ADDRESS : 43 TACTICAL DR SUBDIV: GWEN OAKS 63 LOTS  
 CONTRACTOR : GARY ROBINSON HOMES LLC PHONE : (910) 977-2562  
 OWNER : PARADISE HOMES PHONE :  
 PARCEL : 01-0547- - -0024- -03-  
 APPL NUMBER: 12-50029408 CP NEW RESIDENTIAL (SFD)

**STRUCTURE: 000 000 46X50 4BDR 2.5 SFD W GAR CRAWL**

Re: J0712-4410

G.Robinson-Lot 3-Gwen Oaks/Harnett

Job	Truss	Truss Type	Qty	Ply	G Robinson-Lot 3-Gwen Oaks/Hamett	E6625618
J0712-4410	F2	Floor Truss	6	1

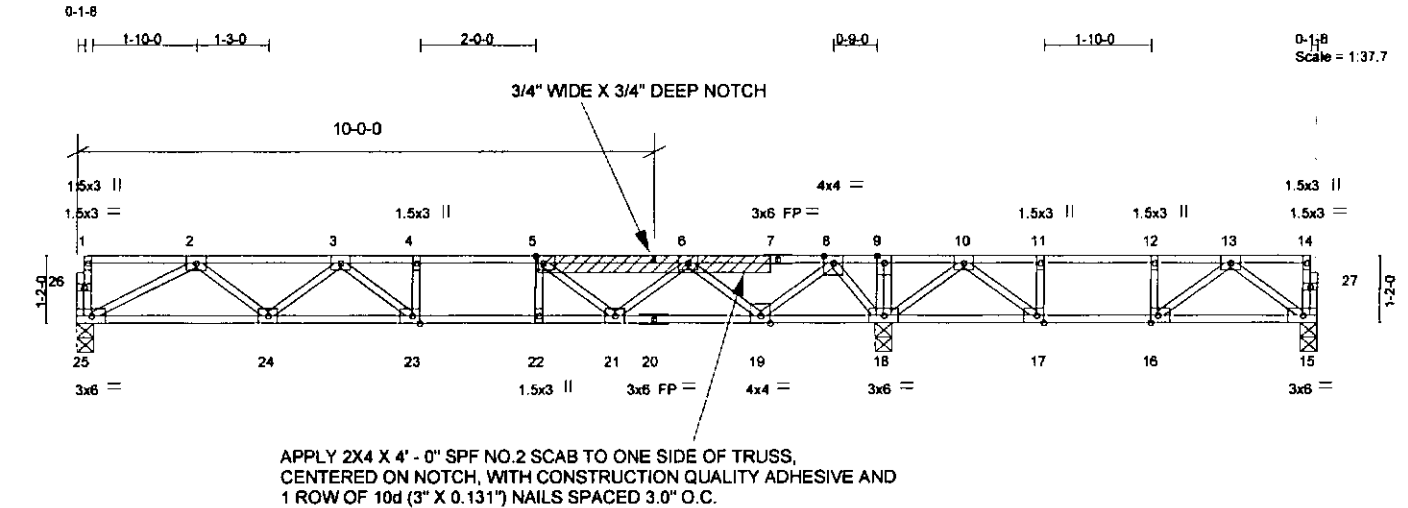
R425 03	11/06/12	DT	FOUR TRADE ROUGH IN TIME: 17:00 VRU #: 002299600
	11/07/12	DA	T/S: 11/05/2012 10:37 AM VBROWN ----- T/S: 11/07/2012 08:31 AM DETAYLOR ----- Need engineer repair for floor truss bored for plumbing Okay to side and insulate
I129 01	11/09/12	TI	R*INSULATION INSPECTION VRU #: 002301141
	<u>11/9/12</u>	<u>AP DT</u>	
R425 04	11/09/12	TI	FOUR TRADE ROUGH IN TIME: 17:00 VRU #: 002301414
	<u>11/9/12</u>	<u>AP DT</u>	T/S: 11/08/2012 02:13 PM DJOHNSON ----- WHEN SCHEDULING AN INSULATION INSPECTION MAKE SURE THE ROUGH IN IS ALSO SCHEDULED IF IT FAILED AT ROUGH IN. OTHERWISE THE INSULATION WILL BE CANCELLED.
